# MANDATORY SERVICE BULLETIN

No. MSB-E4-022/2  
SUPERSEDES MSB-E4-022/1

Waste Gate Control Rod.

Engine type: E4  
Engine model(s): E4, E4P  
Serial number(s): all

Figure 4: Waste Gate Circlip

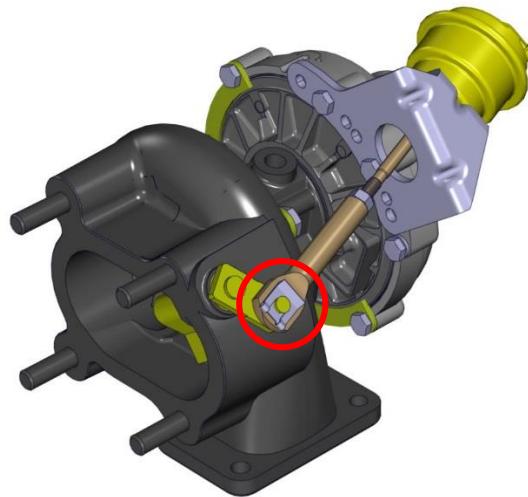
1. Make sure MM-TR-MDC-E4-386 and MM-TR-MDC-E4-399 are inserted into the Maintenance Manual E4.08.04 or a revision of the MM with the Temporary Revisions incorporated is used.
2. Replace the waste gate controller according to Maintenance Manual section 81-00-33.
3. Install a new the spring loaded circlip E4A-41-100-801. Refer to figure 4

1. Replace the waste gate controller according to Maintenance Manual section 81-00-33.
2. Install a new the spring loaded circlip E4A-41-100-801. Refer to figure 4.
